REQUEST FOR INFORMATION NOT ADDRESSED IN THIS CCO REMAIN IN FORCE			
△	03/08/10	MEP INTEGRATION	SYC FW 110
MARK	DATE	DESCRIPTIONS	BY CH'D CCO#
REVISIONS

**DETAILS**  
**BRIDGE STRUCTURES GIRDER WESTBOUND**  
**SKYWAY STRUCTURES-SERVICE PLATFORM #13W**  
 SCALE AS NOTED

**E-643**

**CONDUIT AND GROUNDING PLAN - WB**  
 SCALE: 1:40

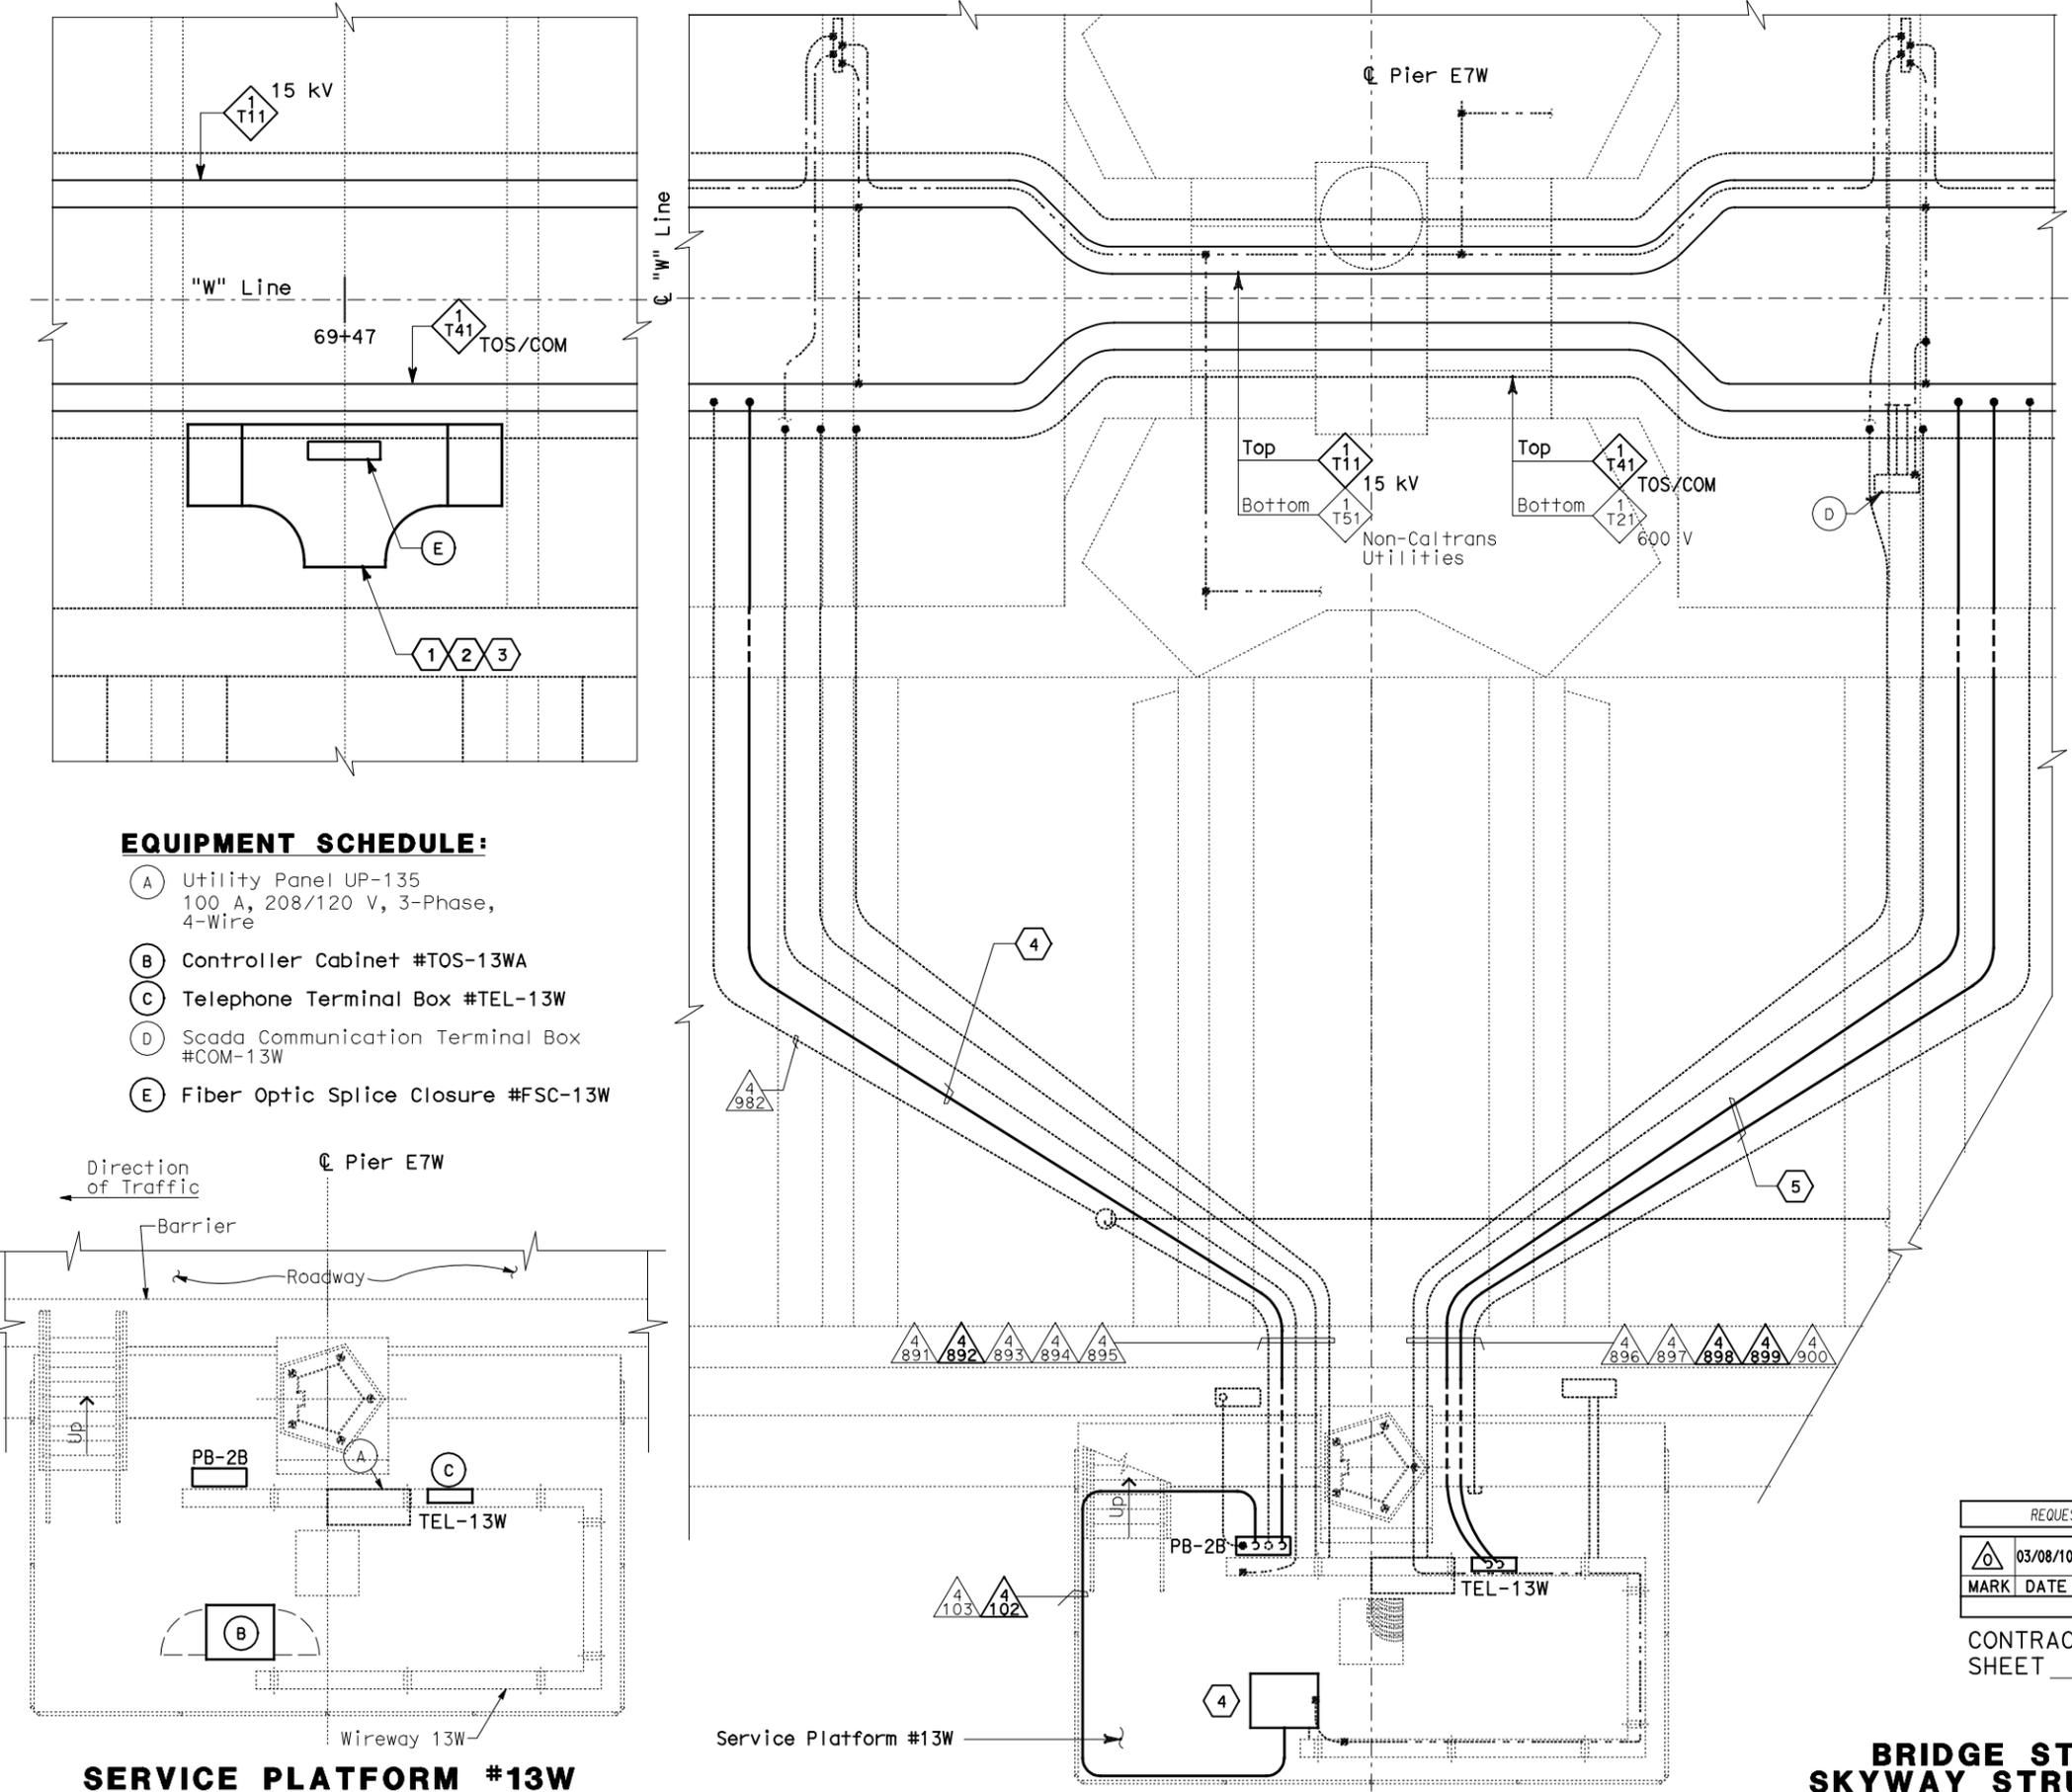
- Furnish and install splice cable tray as shown on sheet E-663, plan detail 2.
- Mount splice cable tray between diaphragms and secure properly. See sheet E-663, section detail 4.
- Contractor shall locate the splice cable tray at Station 69+47 as shown on sheet E-605.
- Furnish and install 12 fiber optic cables from Fiber Optic Splice Closure to Controller Cabinet. Route via pull box PB-2B. Coil 3m of cable inside Controller Cabinet for connections by others. The coiled end of the fiber optic cables shall be terminated with mated connectors. See sheets E-972 and E-973.
- Pull and terminate 50 pair telephone cable in Telephone Terminal Box. See sheets E-960, E-962 and E-964.
